December 10, 2019

**Addendum No. 01
TO THE CONTRACT DOCUMENTS FOR:**

MANSFIELD FIRE STATION NO. 4

KAI Project No. 2016.166

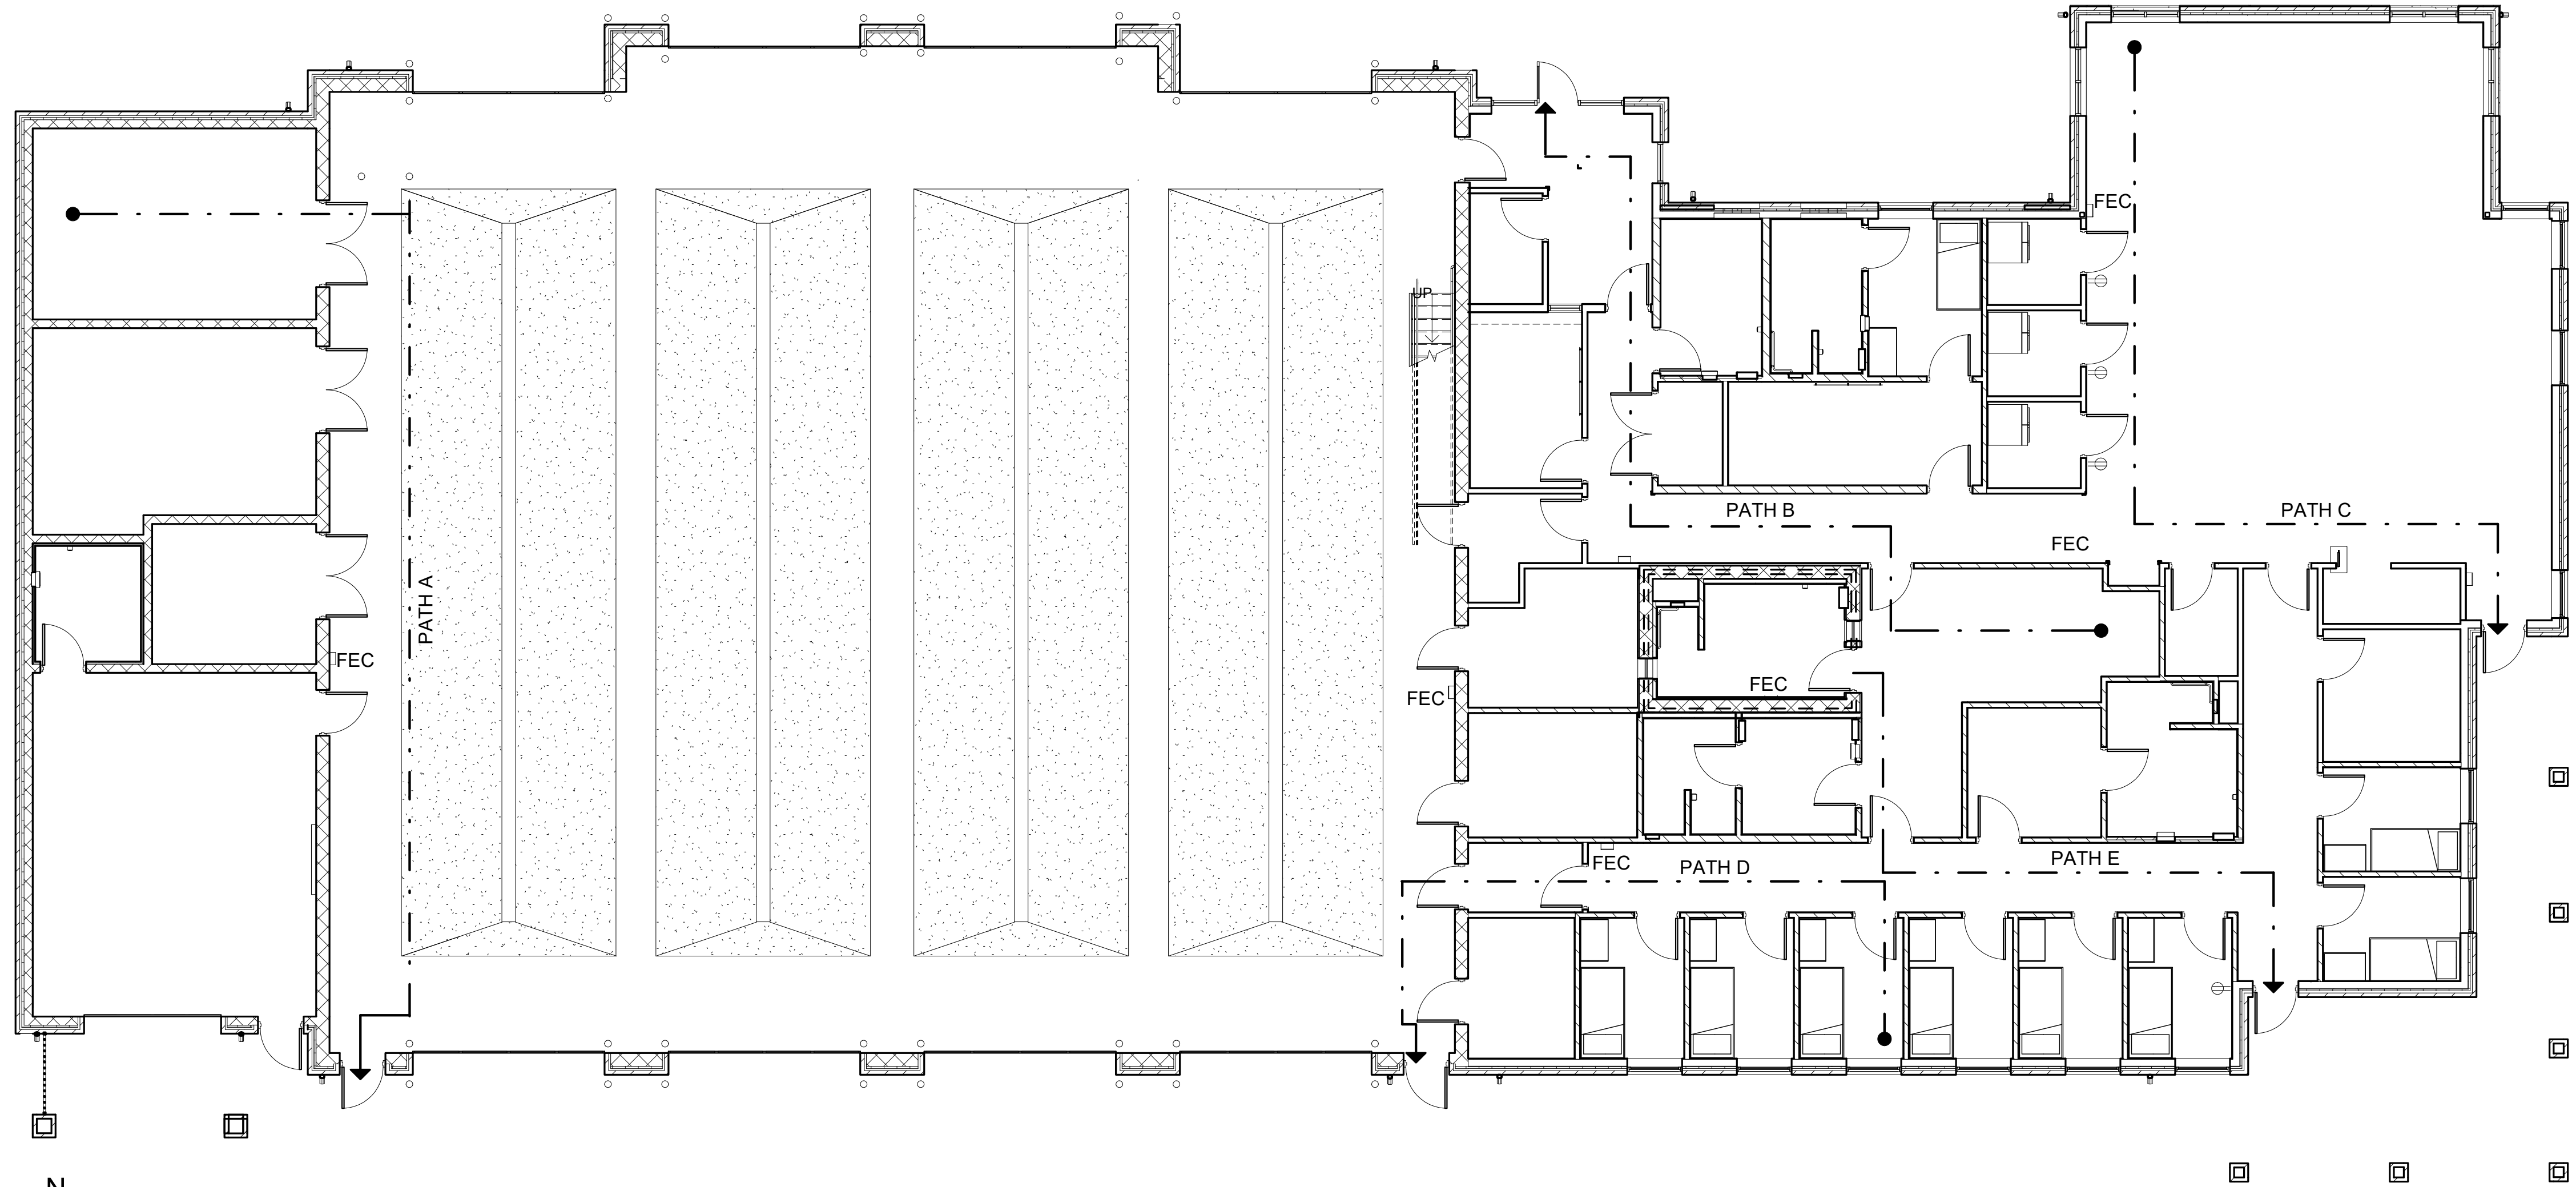
1. Sheet G0.02 – Clarification: In the first code column from the left of the sheet revise the Occupant Load from 100 to 150
2. Sheet C1.0 – See revised sheet for added fire lane notes. Added some additional conduits to the north side for future use.

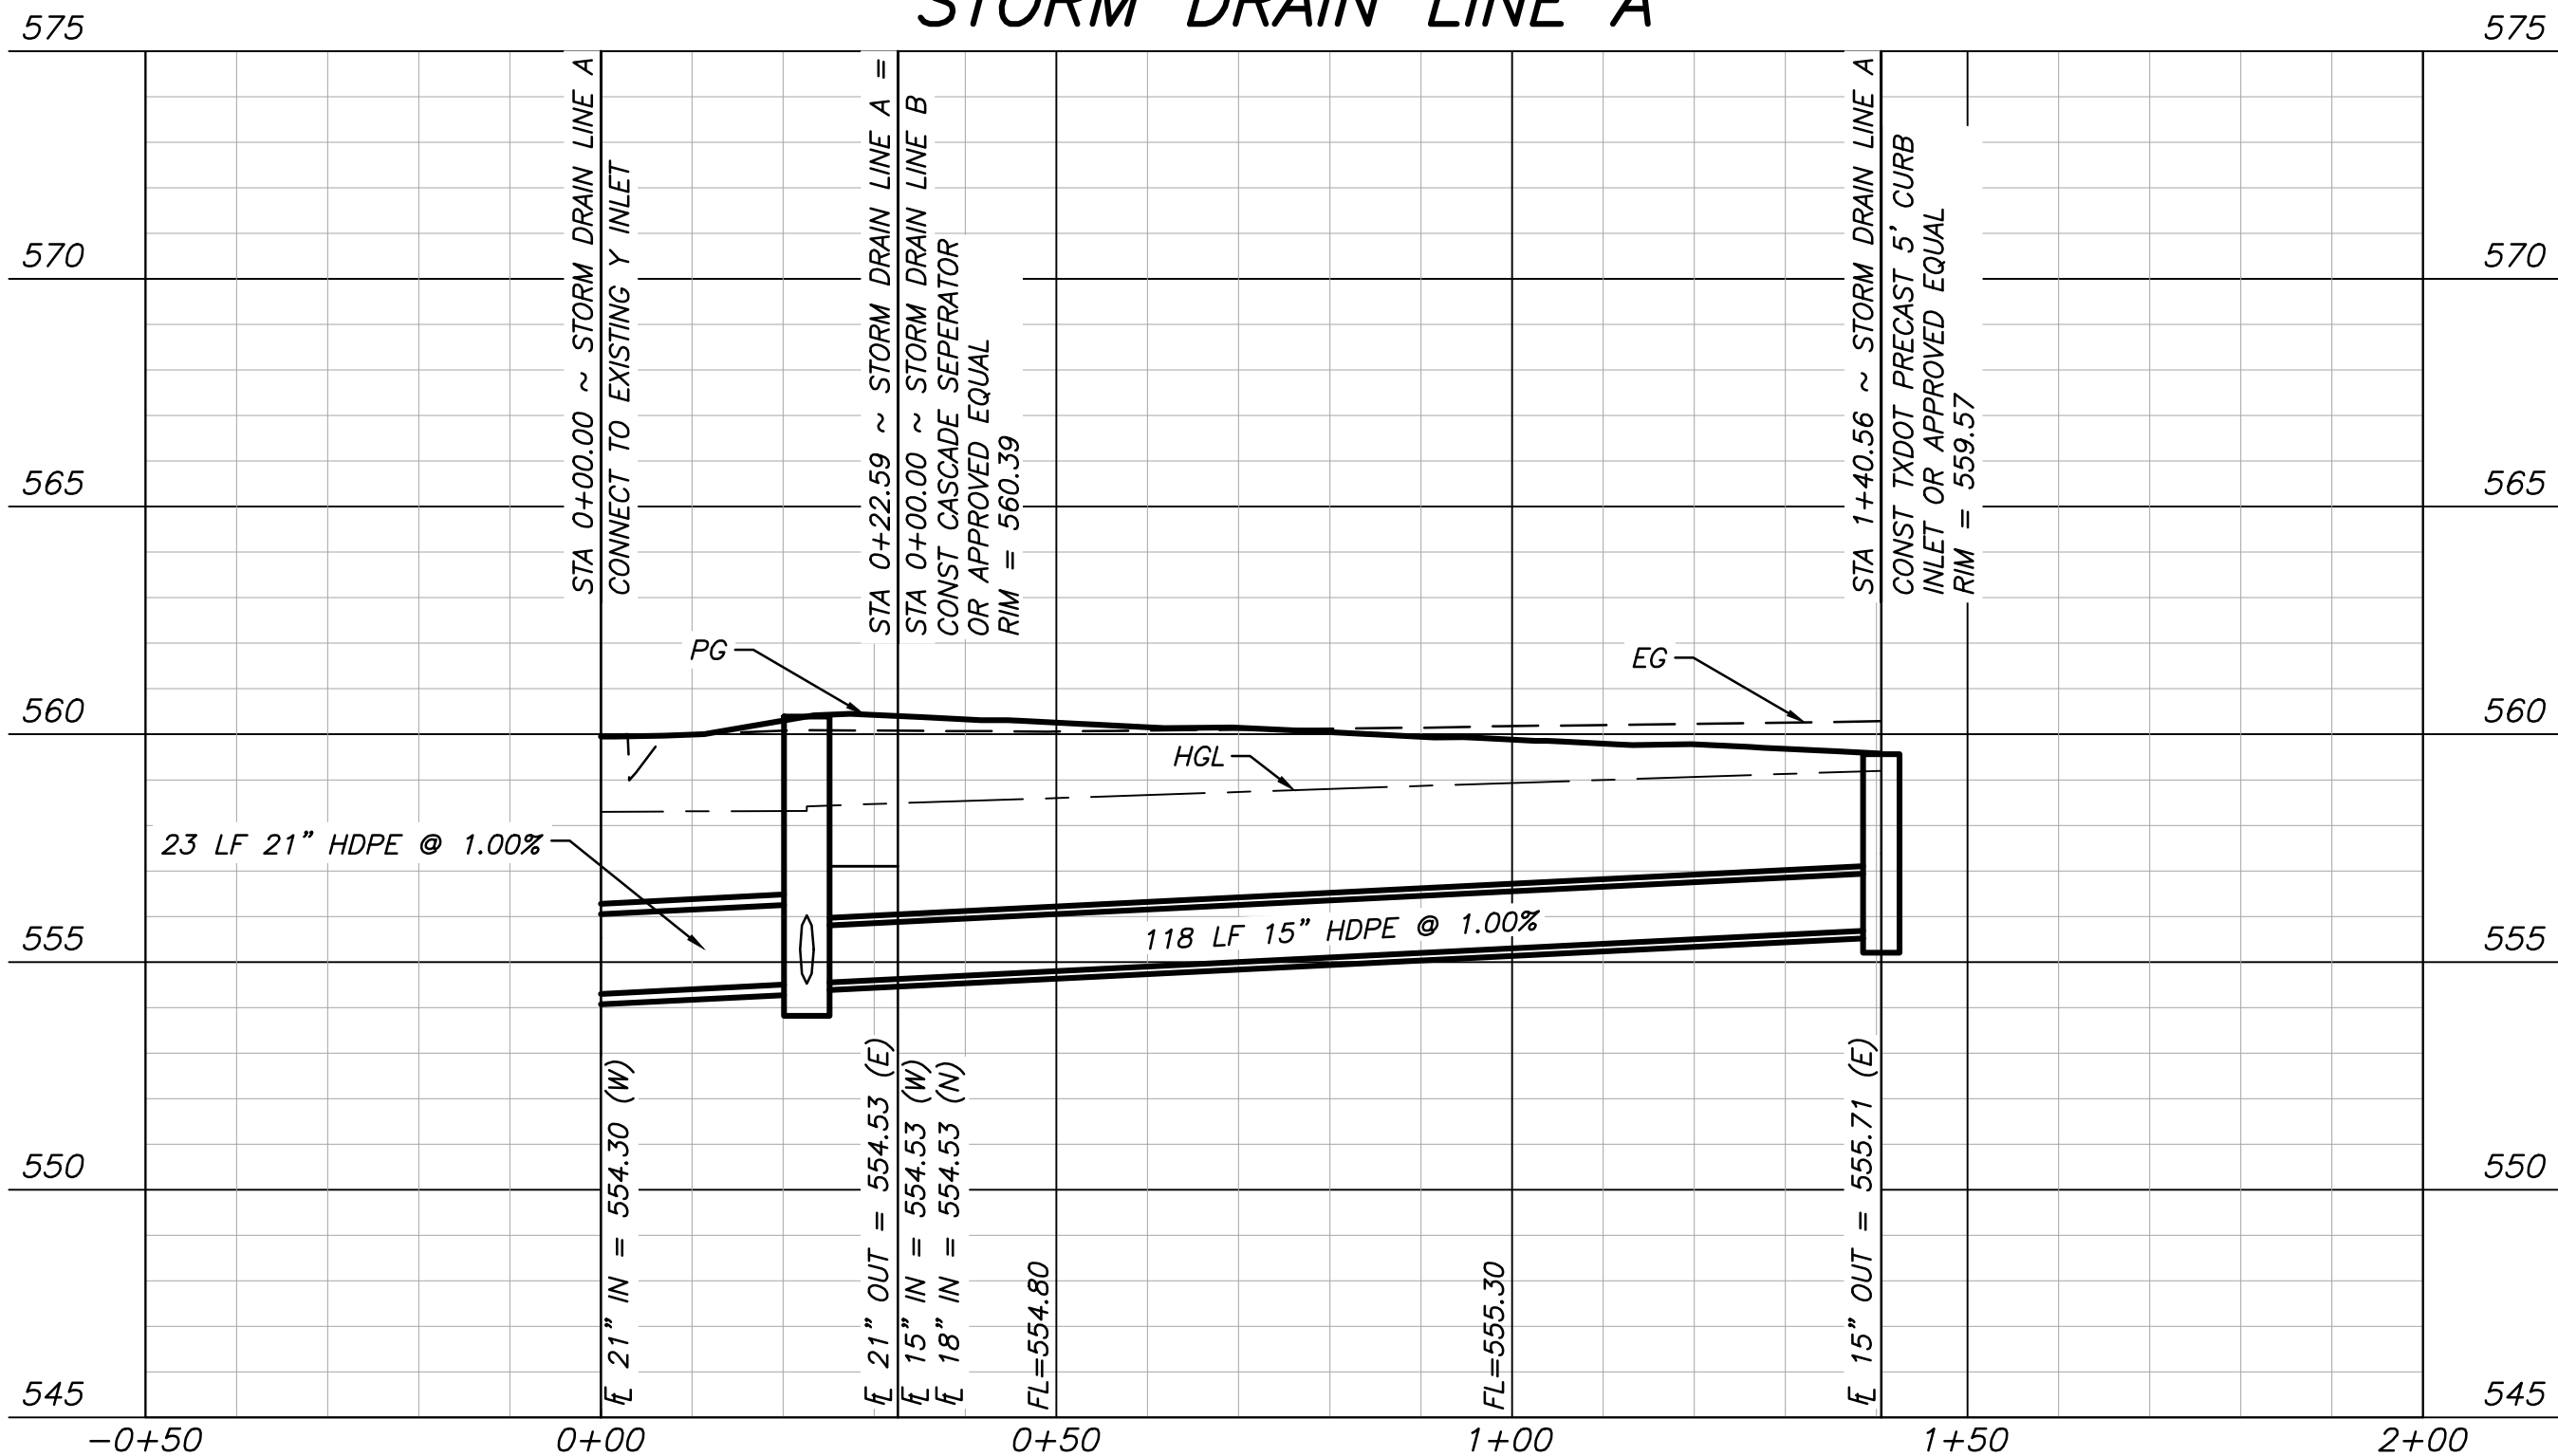
3. Sheet C4.1 – STC Stormceptor detail changed to a cascade separator detail.
4. Sheet C4.5 – STC Stormceptor detail changed to a cascade separator detail and accompanying calculations.

CHANGED TO CASCADE
SEPERATOR

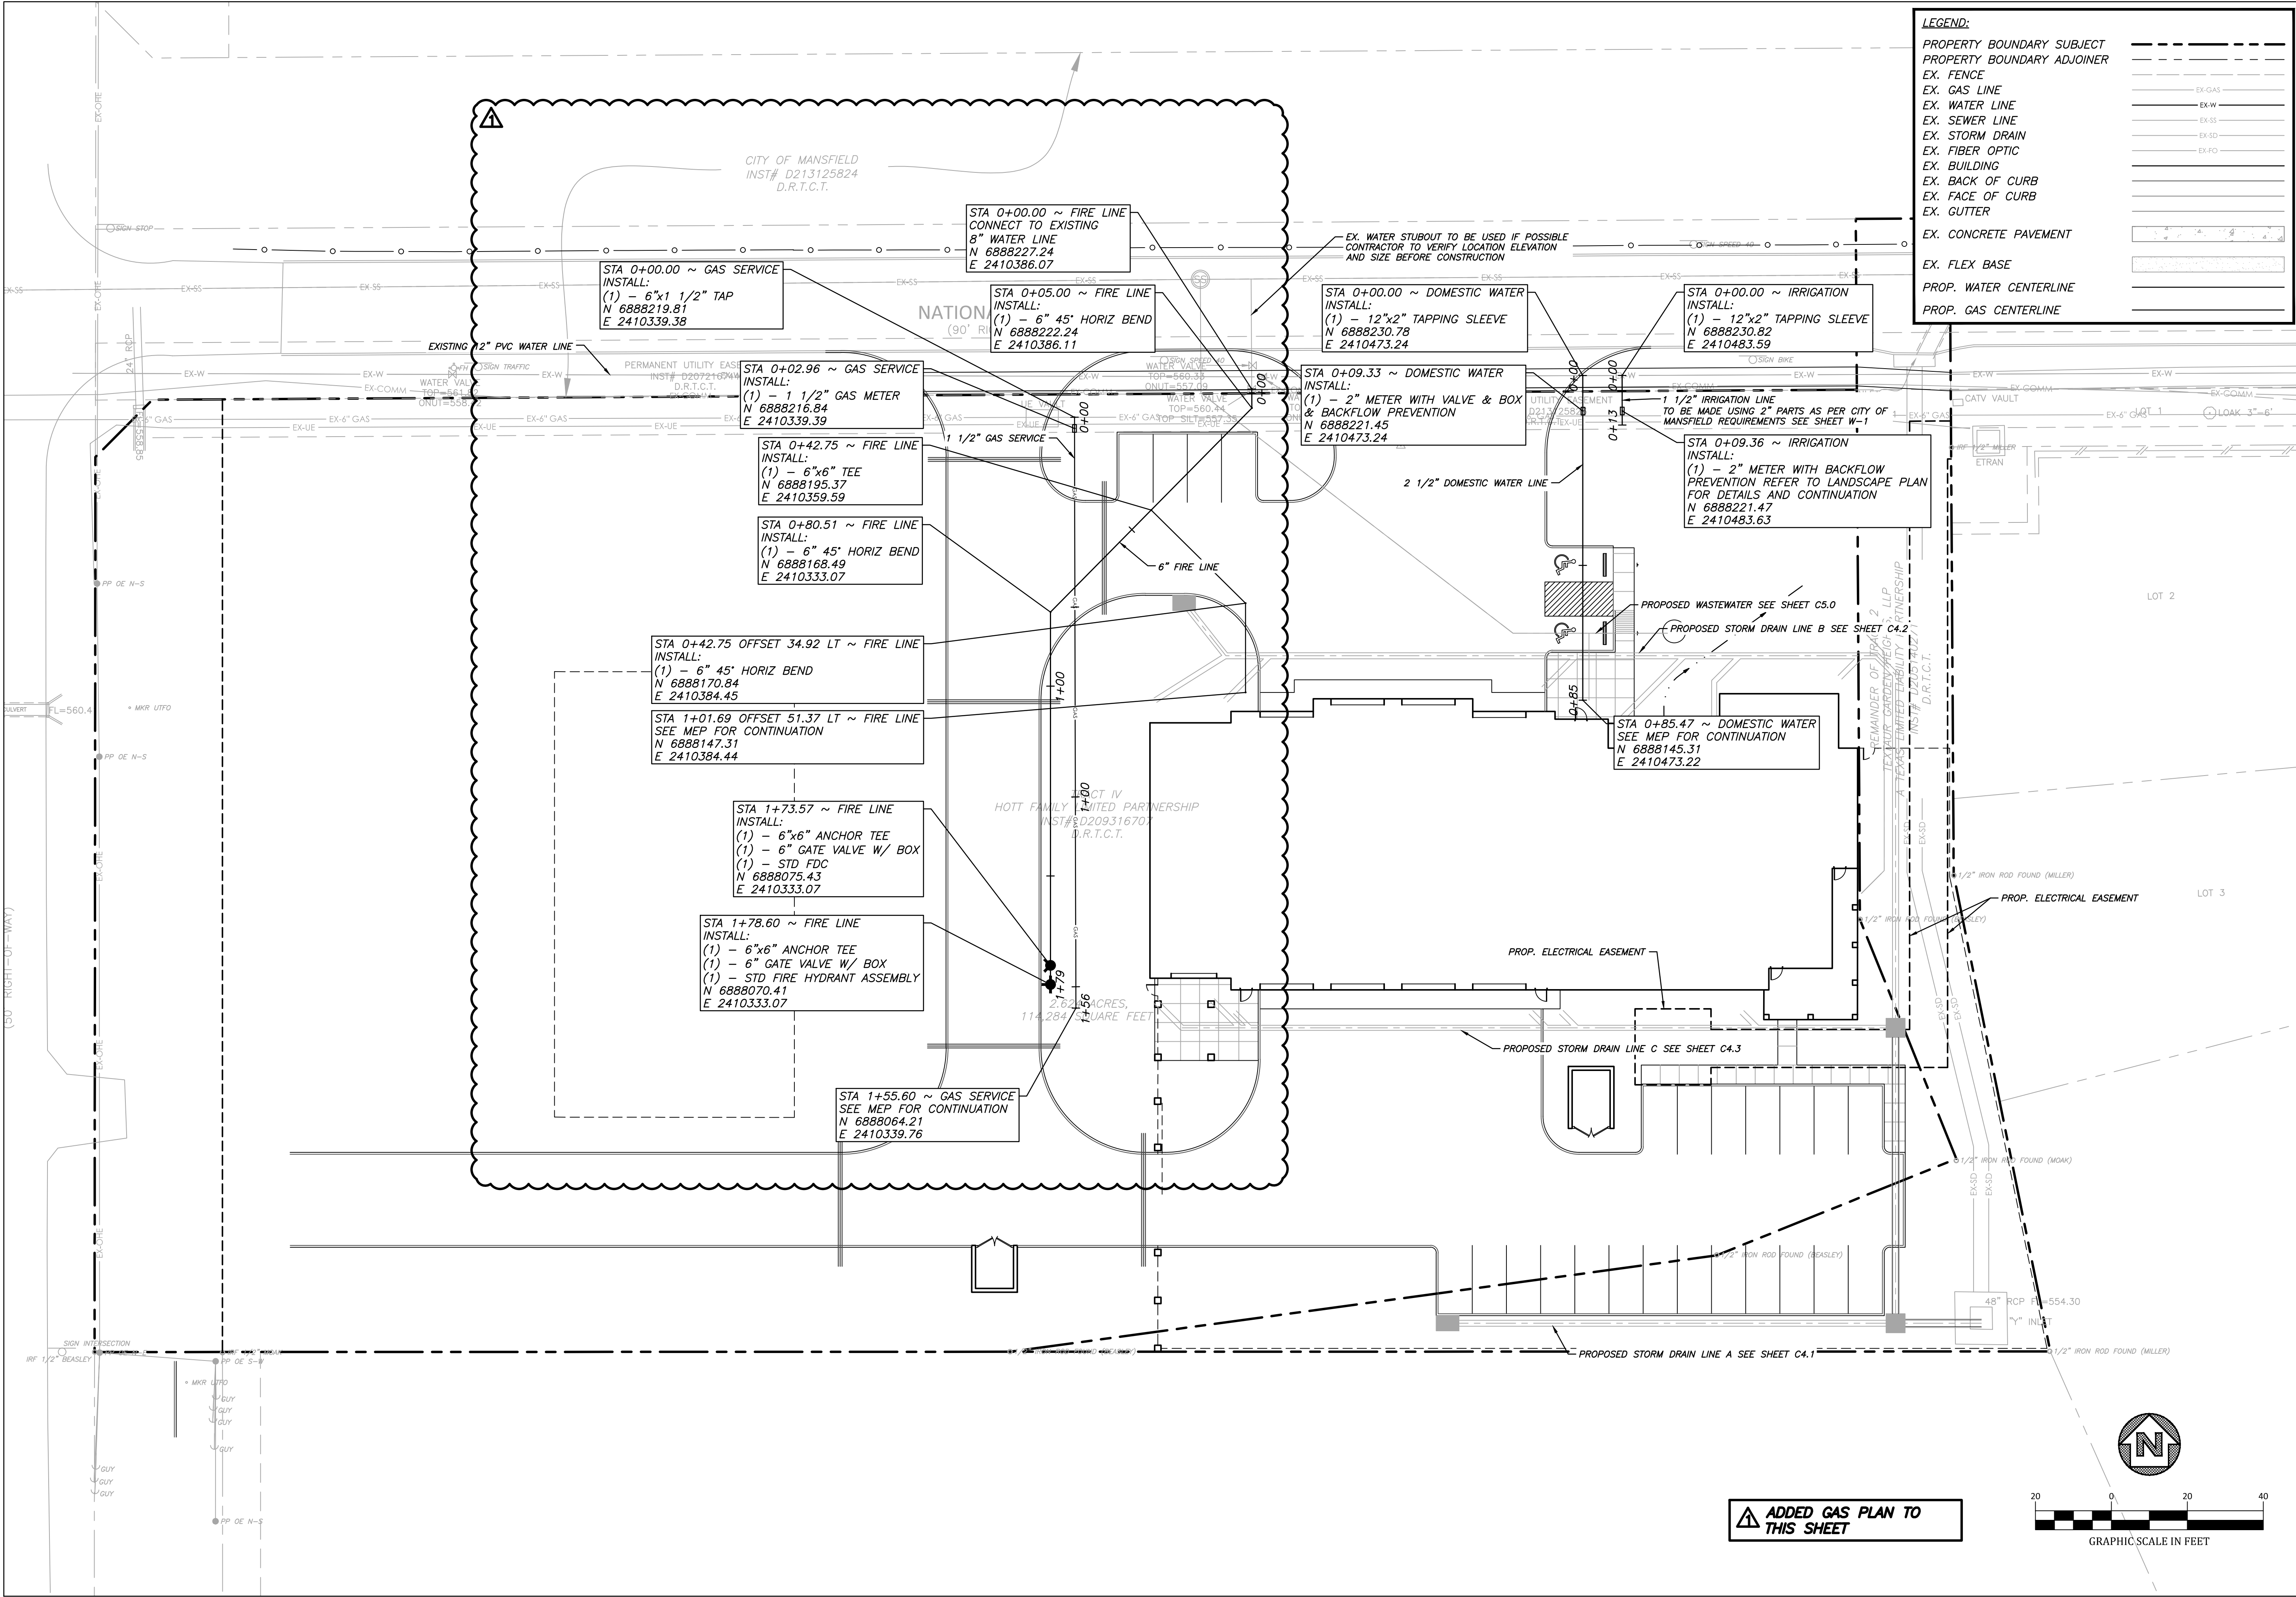
5. Sheet C6.0 – Added sheet to set showing gas lines
6. Sheet C9.0 – See revised sheet for revised paving area around the building
7. Sheet L.01 – See revised sheet to show drive revision to Holland Lane

ADDED GAS PLAN TO THIS SHEET
